Re: **Certification for Permanent Certificate of Occupancy (C.O.)**
Richfield Park, Lot 5-A-1, 4545 Alameda Blvd. NE
DRB Project 1005410 (C-17/D120))
Certification Dated 4/17/13

Re: Richfield Park Lot 5-A-1
Grading Plan Certification—Accepted
Engineer's Stamp date 8-29-13 (C17/D120)
Certification date 04-10-13

Re: 4545 Alameda NE–Grading & Drainage Plan
Lot 5A, Richfield Park Subdivision

Re: Lot 5A Richfield Park – Conceptual Grading & Drainage Plan (C17-D120)
aka: Lots 4 & 5, Richfield Park Subdiv. (No P.E. Stamp: <Plan dated 5/21/12>)

SHEET
CG-101

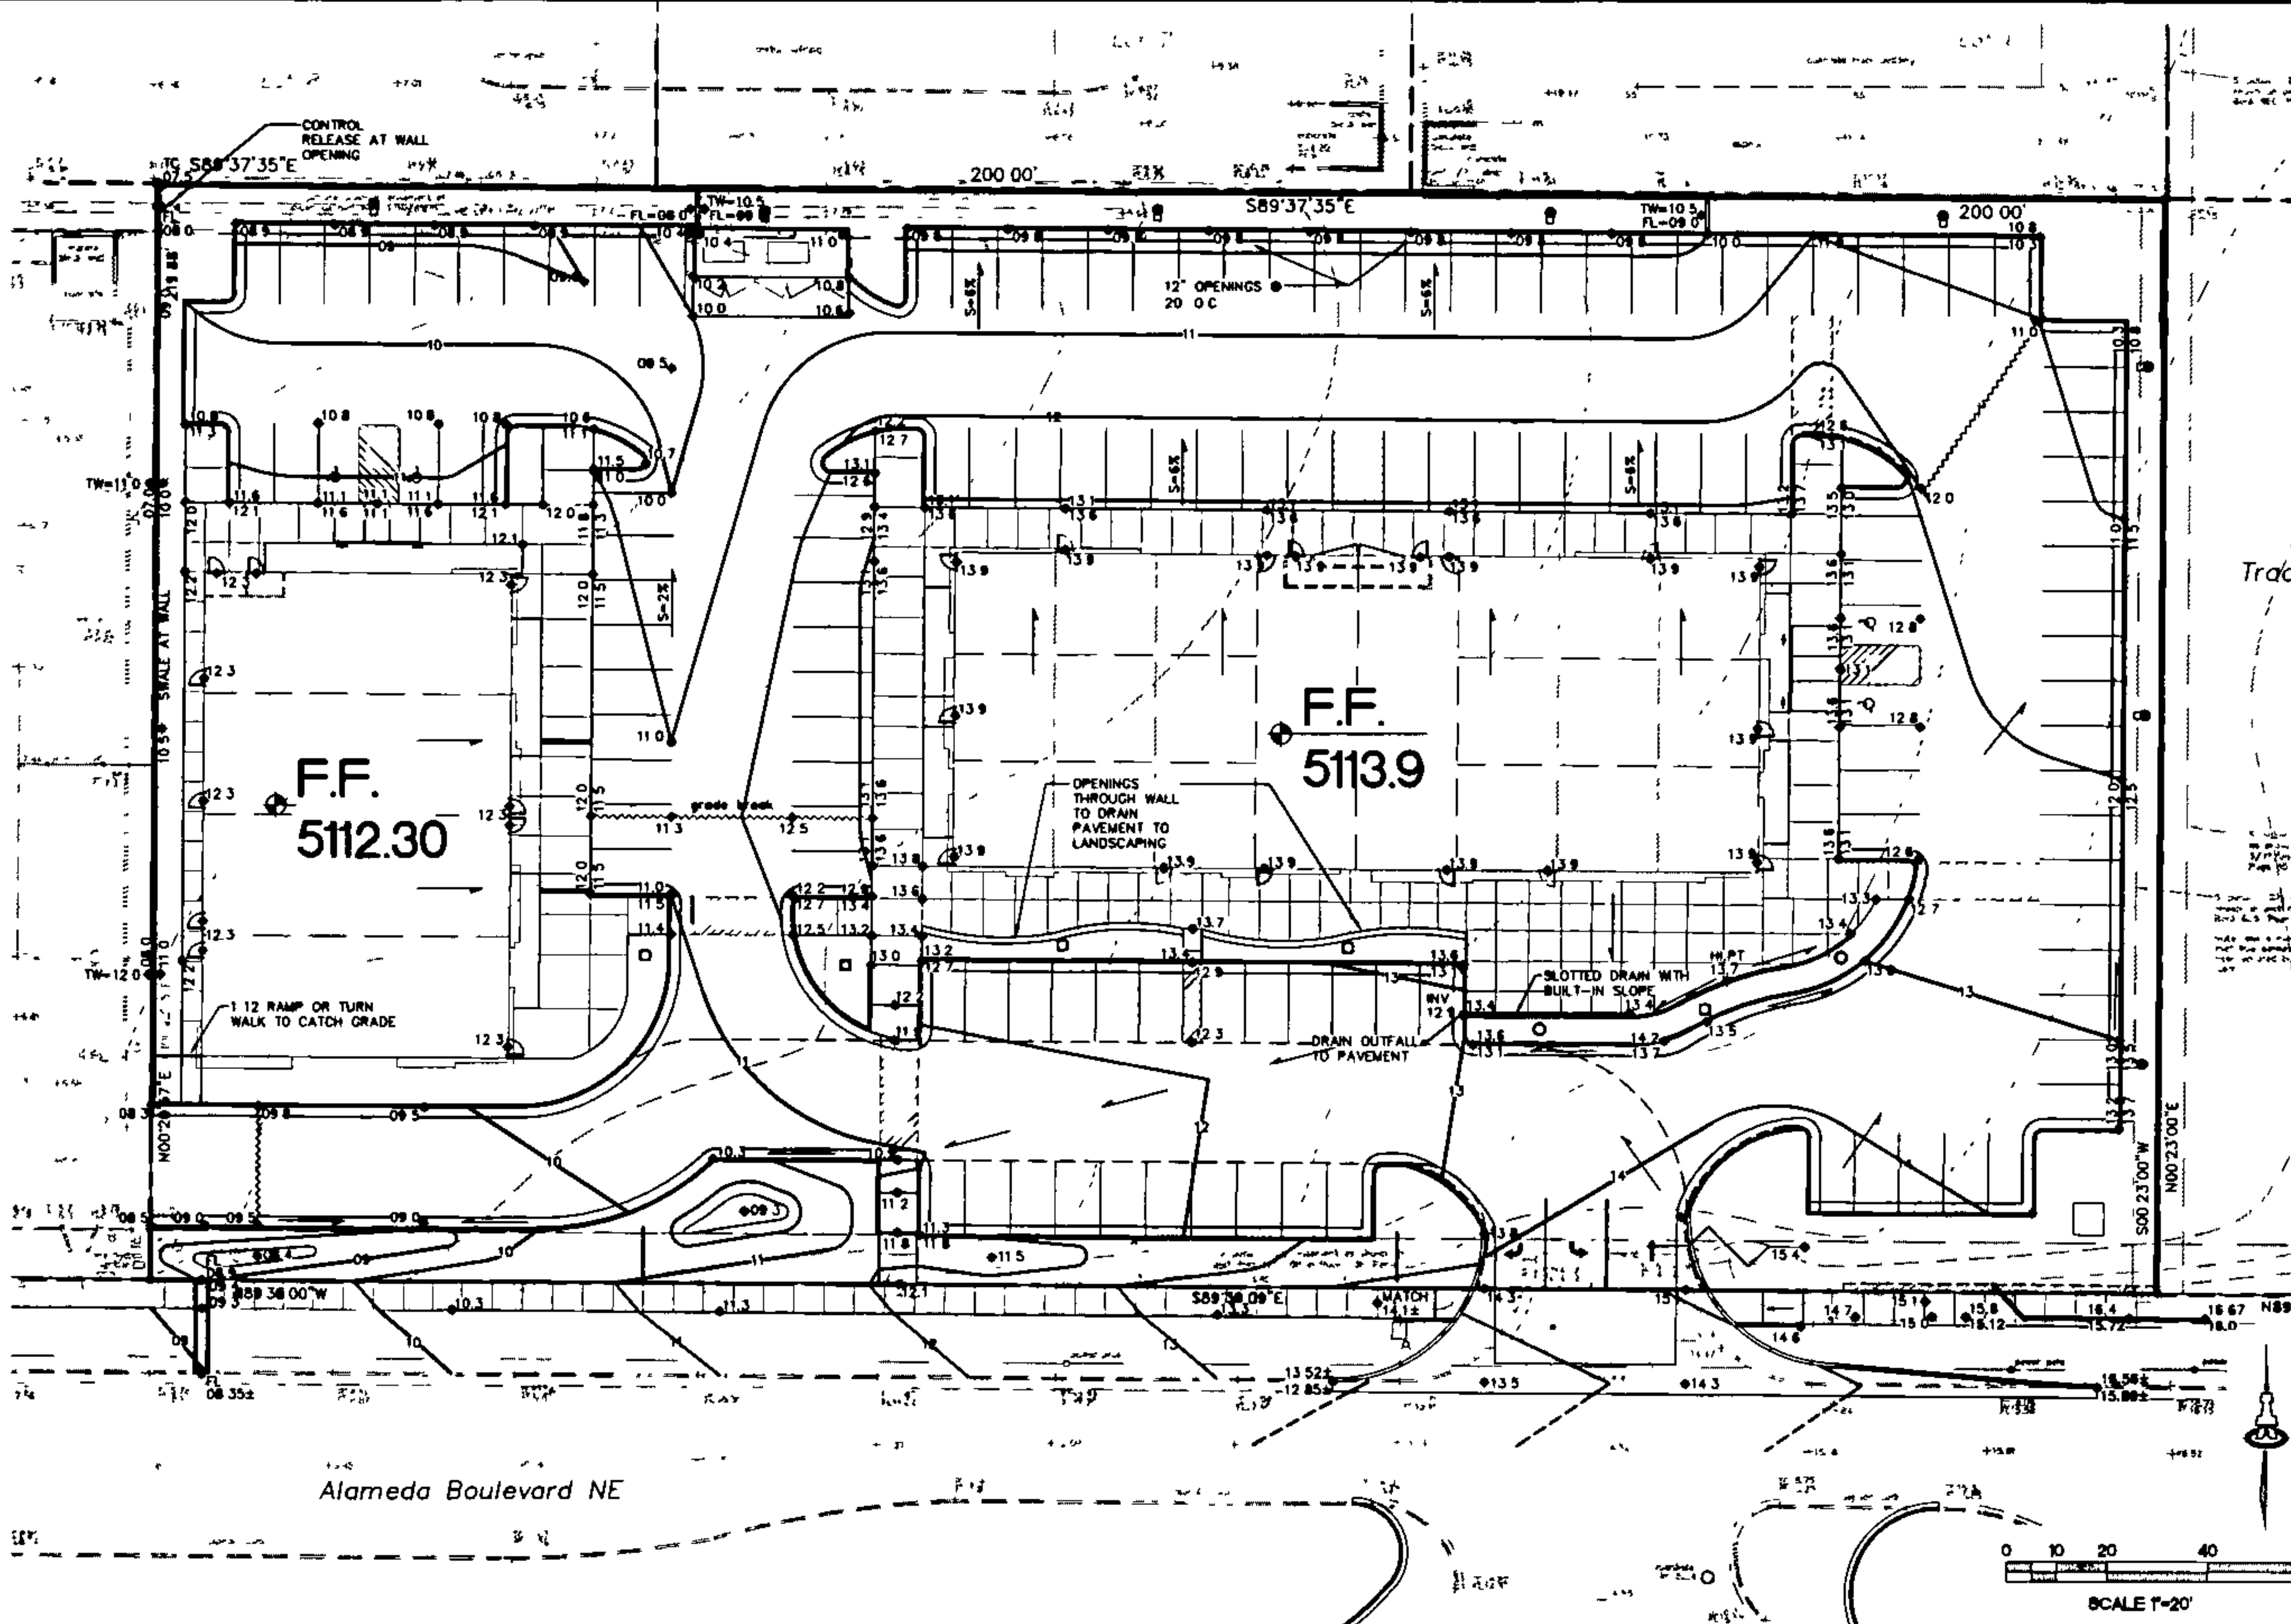
1. Offsite flows appear to be possible from the east. We have no record of development on Parcel C1-D to the east of this site. Provide documentation with photos and topography that offsite flows will not enter this site.

2. The concept of Basin 1 discharging to Alameda Blvd. will be allowed, but the peak discharge rate must be kept close to 2 cfs. Building Permit plans should provide details of how the flows are routed through the water harvesting basins in the southern landscaped areas, and what the peak discharge will be at the SW corner of the site. Provide sufficient detail to ensure that flows intended to leave the site through the sidewalk culvert do not overflow the sidewalk or west property line.

3. Provide more detail of how Basins 2 & 3 will be routed through the terraced ponds on the North and West boundaries, and weir or orifice calculations demonstrating the restriction of discharge to 2.11 cfs at the NW corner of the site.

Attached are two copies of the revised Grading and Drainage Plan for the above-mentioned project.

Although the Drainage Master Plan for the Richfield Park Subdivision prepared by Espey, Juston & Assoc. (1986) permitted free discharge for the majority of properties within Richfield Park Subdivision, there was a noted exception. Lots 2, 3, 4 and 5 were to detain stormwaters on-site and release at a controlled rate of 2.11 cfs/acre to a drainage easement running west along the north ends of the properties. The reduced discharge rate was not based on available capacity in the streets and storm drains but because the drainage easement cross-section limited.

We have made every attempt to abide by the requirements but cannot solve the site without a fenced ponding area (depth greater than 18") and a shallow storm drain system which would not gravity drain (bubble up at outlet – maintenance issue). Both of these solutions are unacceptable because they are visual eyesores, high maintenance and expensive to construct.

We propose permitting a small basin (0.6 acres @ 100-year, 6-hour discharge of 2.7 cfs) to discharge to Alameda Blvd. This small exception would eliminate both the deepened pond and the need for a shallow storm drain system.

The existing 54" dia. storm drain within Alameda adjacent to our site transitions to a 72" diameter pipe just beyond. The reason for this is the extent of upstream basin draining through this system. A proposed increase of 2.7 cfs would represent an insignificant increase to the total. Plus, due to the location of our site, towards the end of the system, it can be assumed that the discharge from this property will pass before the peak. Please don't hesitate to call with any questions or concerns.
